ADDENDUM 7

DATE: June 29, 2023

Contract: **22-C-00001; Tampa Multimodal Network and Safety Improvements Project (West River District BUILD)**

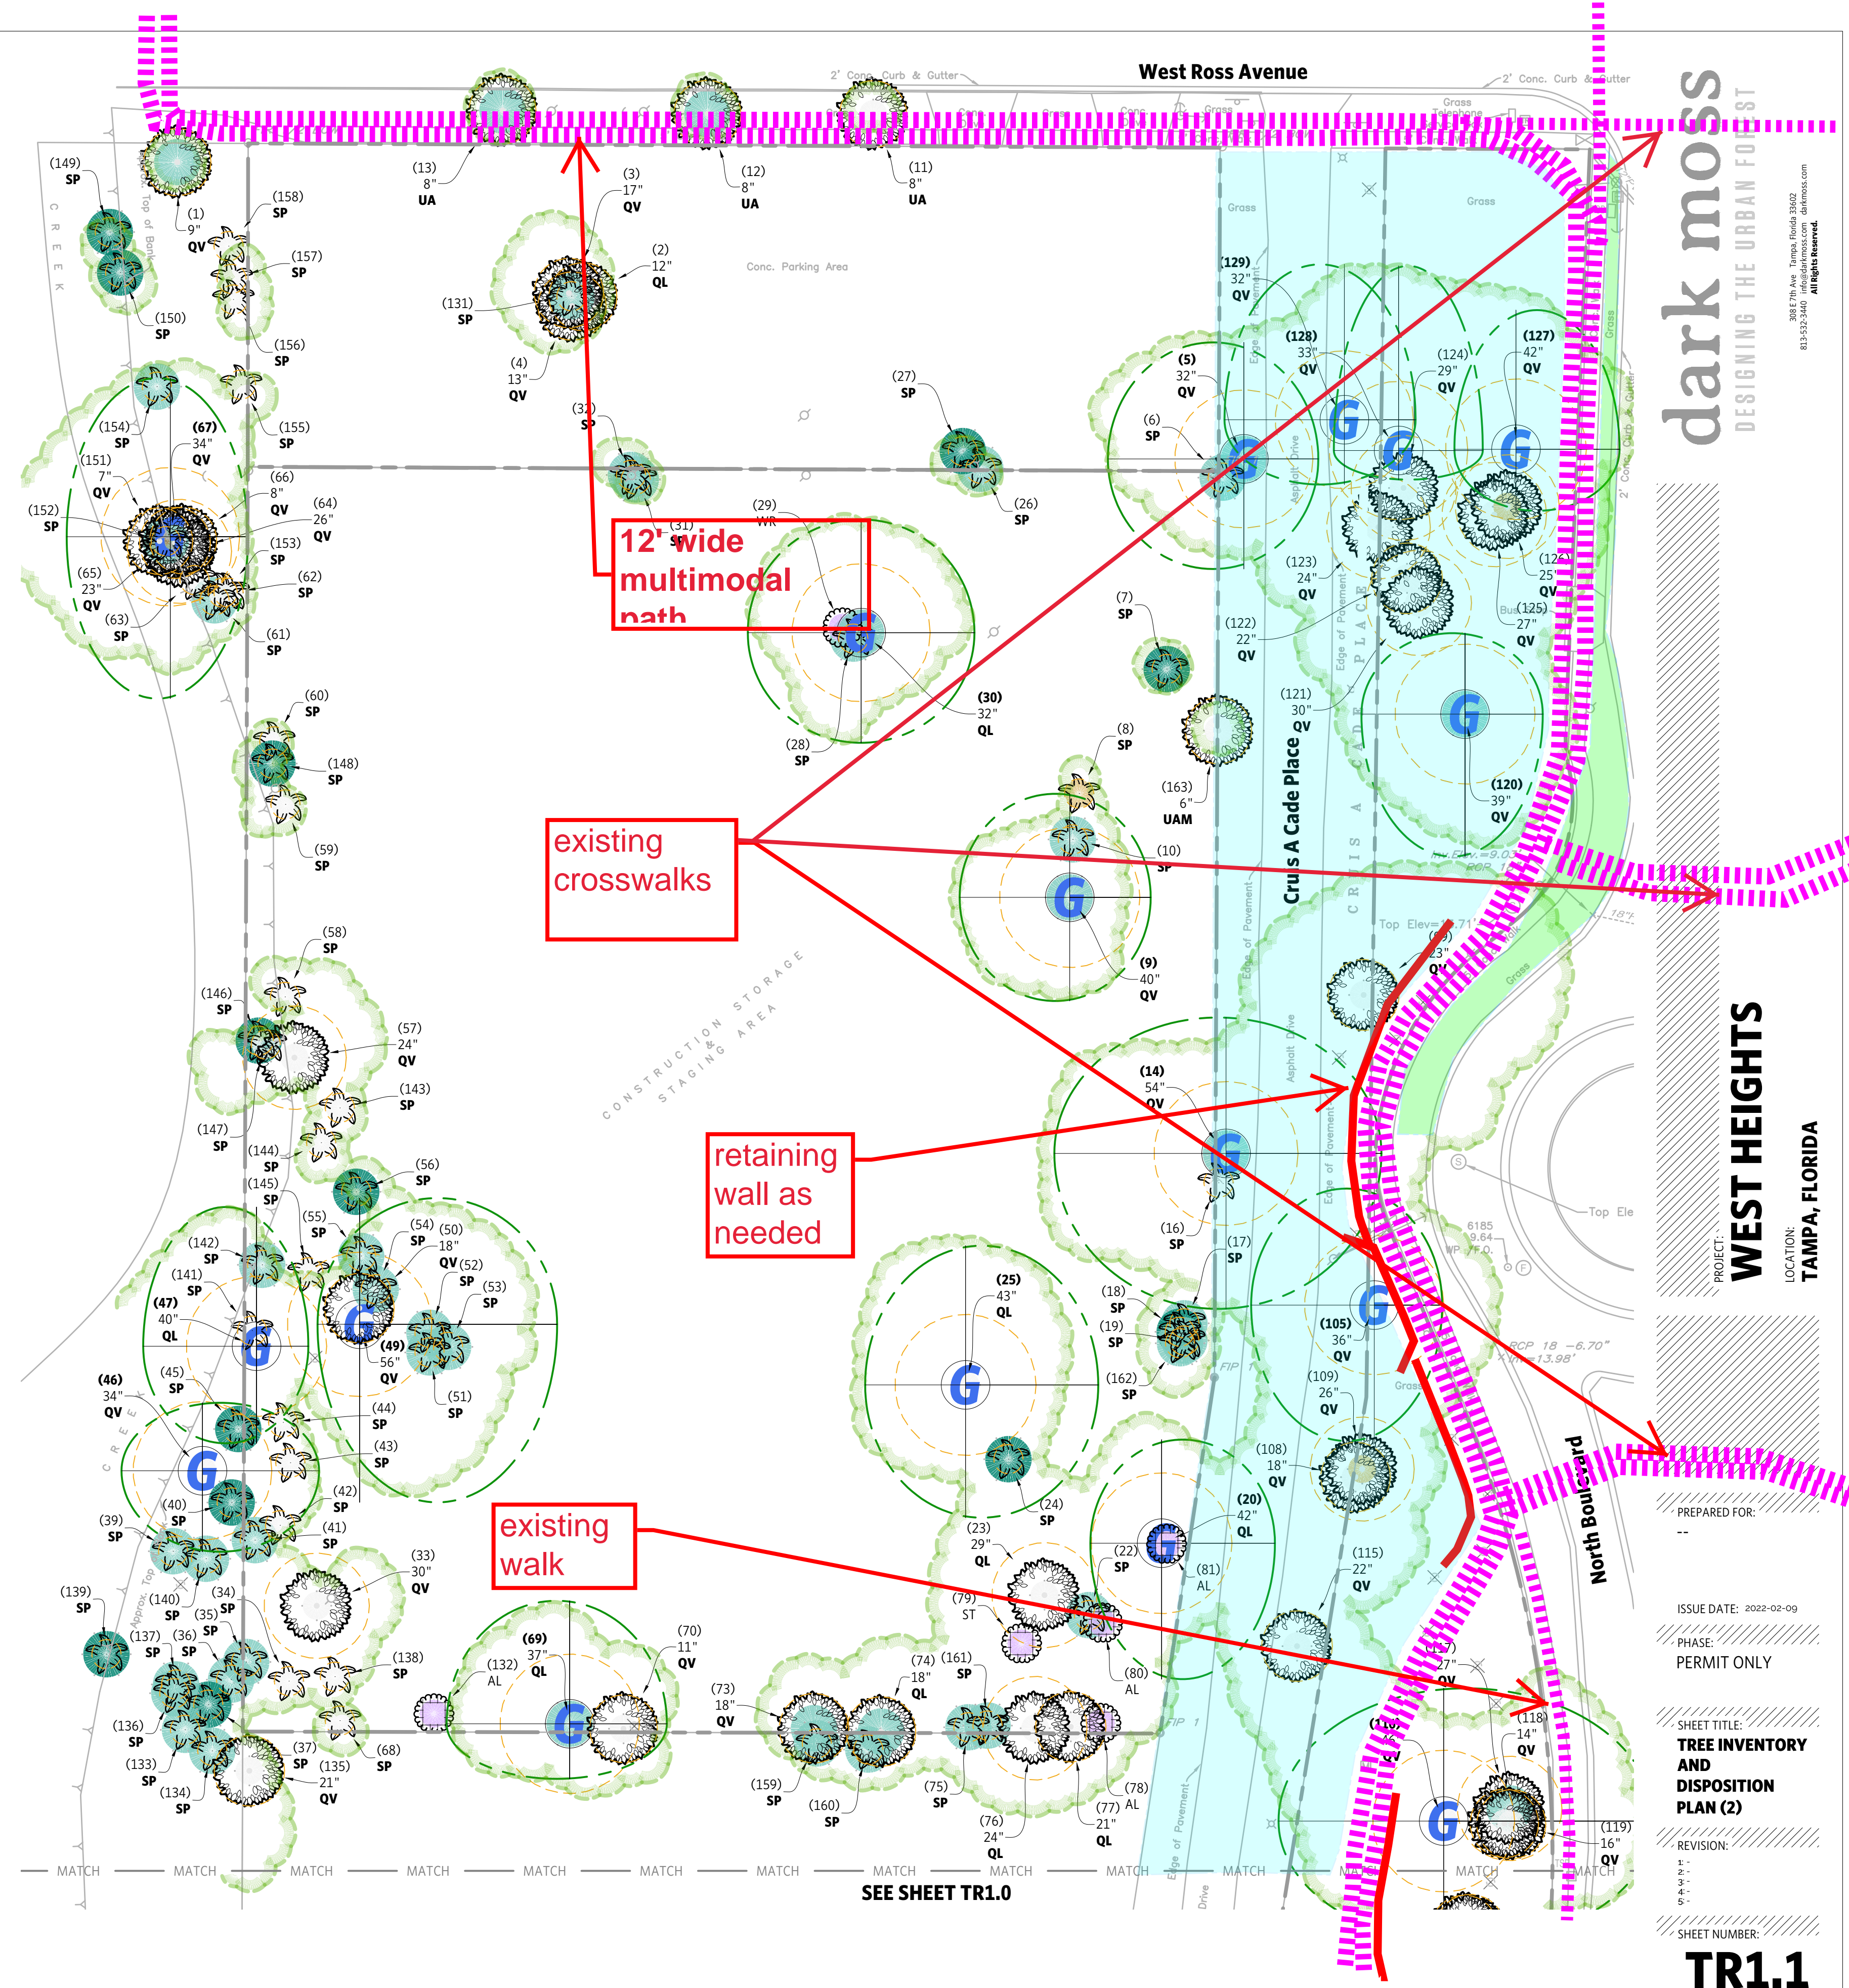
c. If the EOR provides a bi-directional cycle track on the east side of Rome Ave — must the separator between the track and vehicle lanes be raised concrete across its full 3-ft width?

R: The separator should be a physical raised separator (hardscape), concrete or paver. In areas where a three-foot separator cannot be maintained, due to the minimal length, such as spacing between two driveways would not allow for a separator of significant length, other pin down separators and delineators may be considered in that span.

SKETCH OF DESCRIPTION

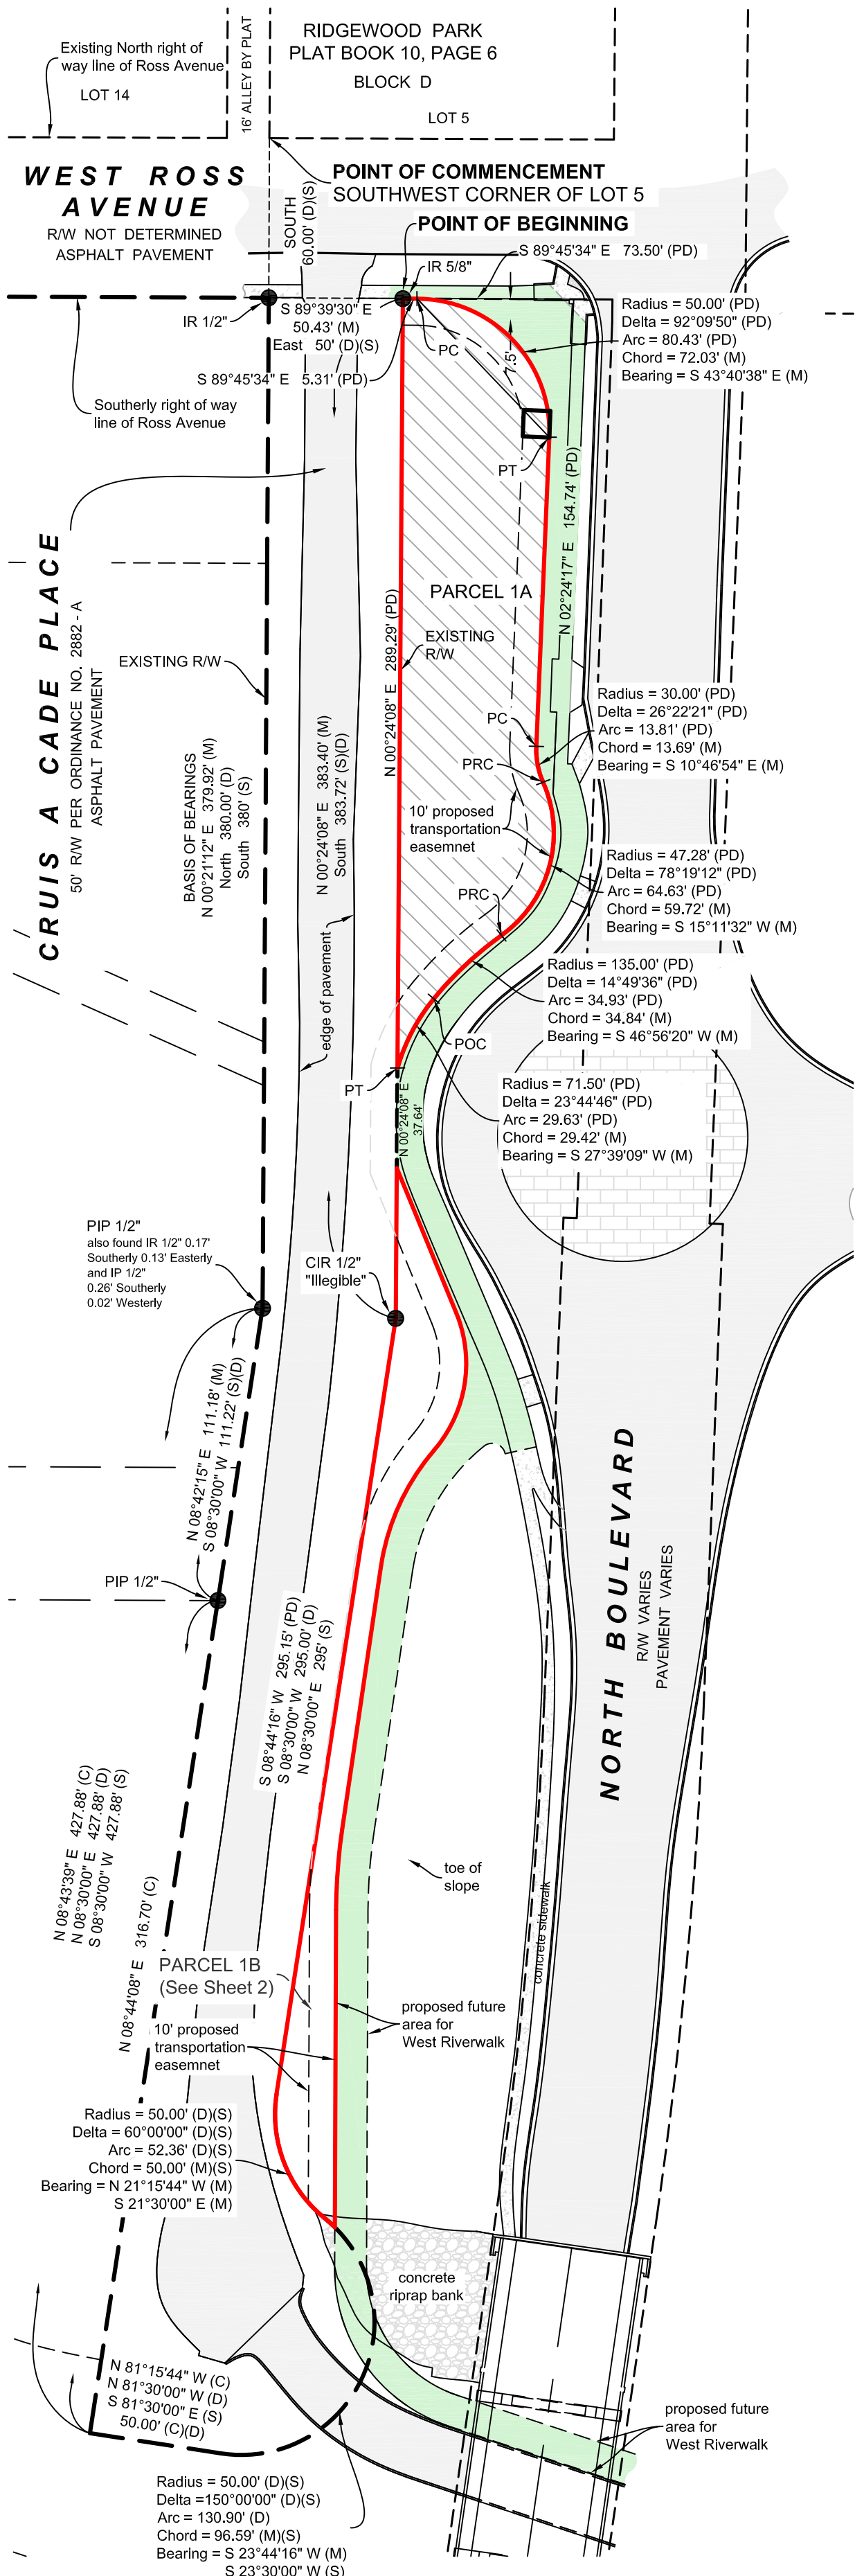
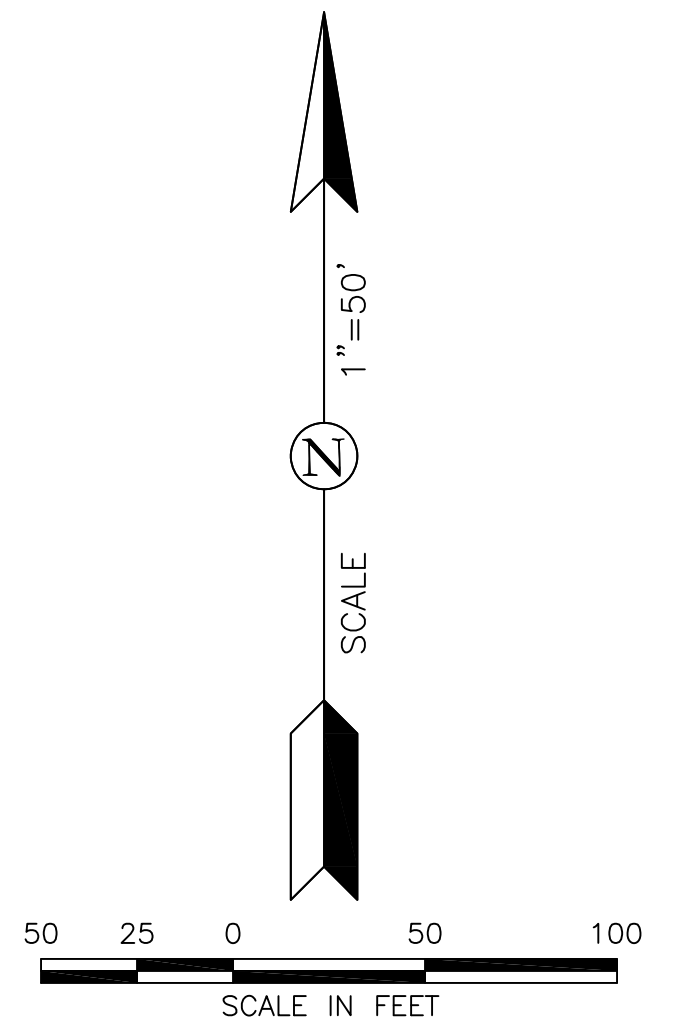
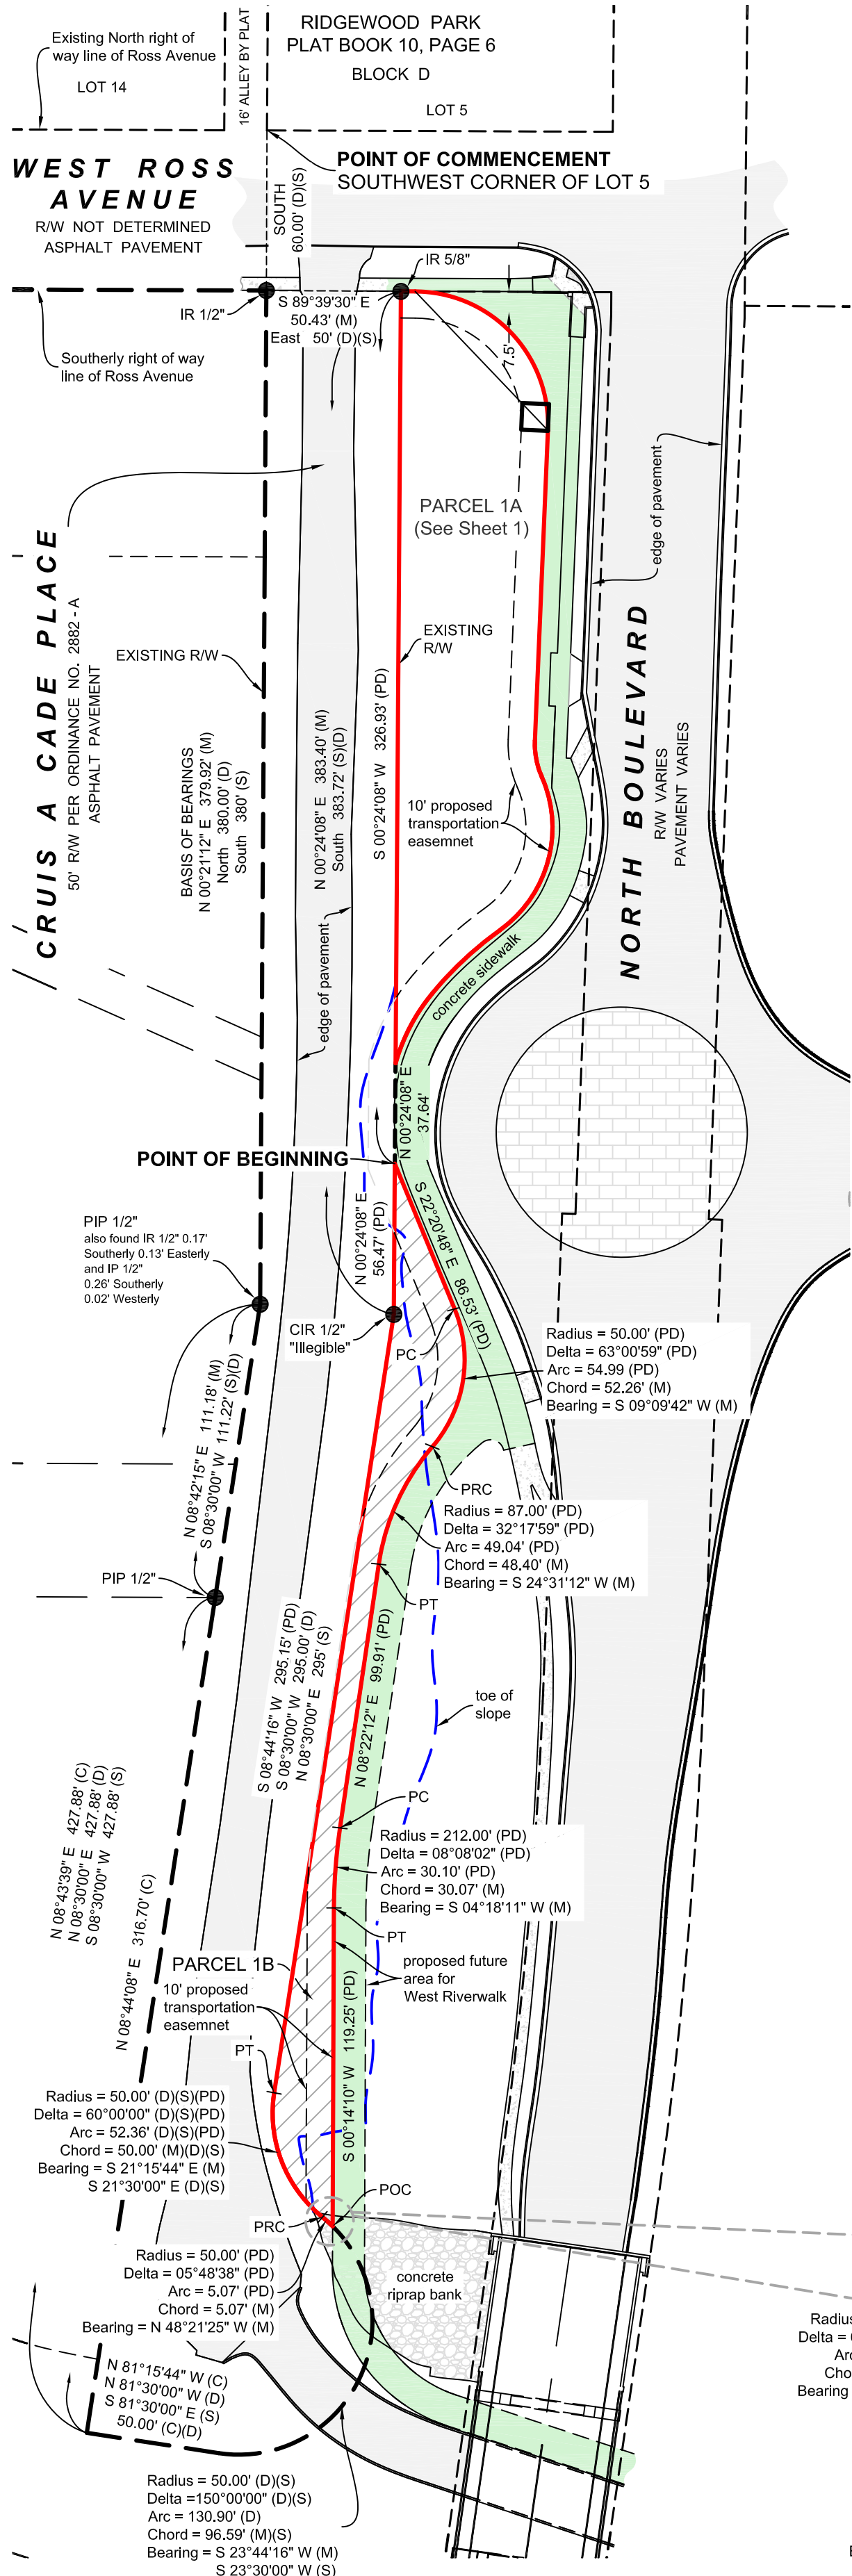
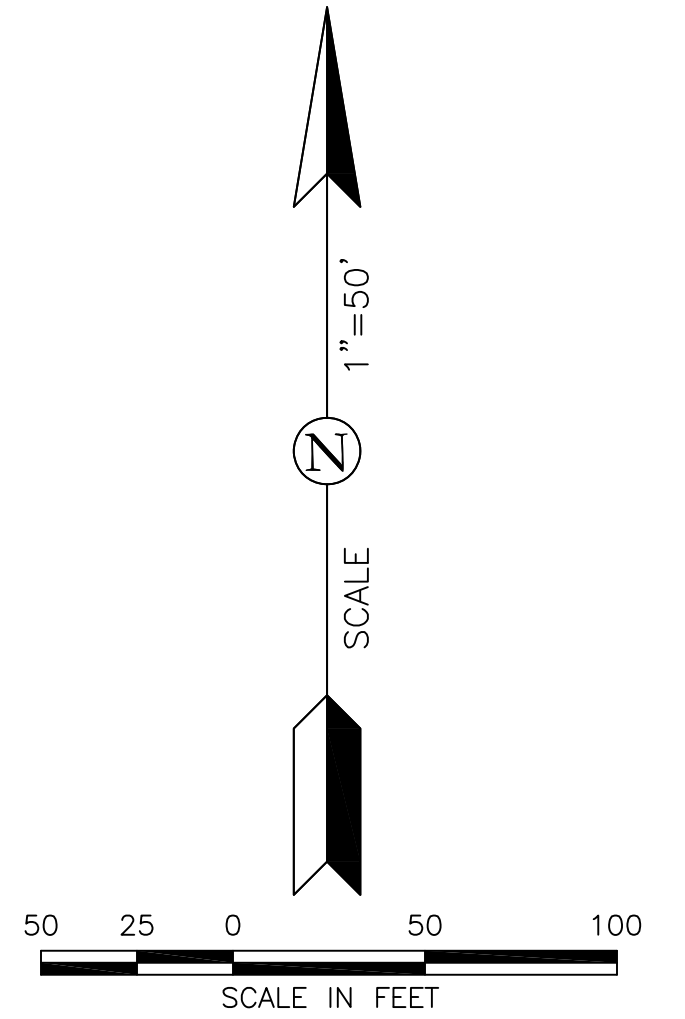
R: I see you located the Preliminary proposed trail alignments west of North Boulevard, in R11. Yes, please include the Segment 6 Alignment option, adjacent to the west side of North

Boulevard, in your Technical Proposal. The Draft easement for the proposed trail alignment on the west side of North Boulevard is attached. Existing trees in this area, are to be protected/retained to the maximum extent possible.
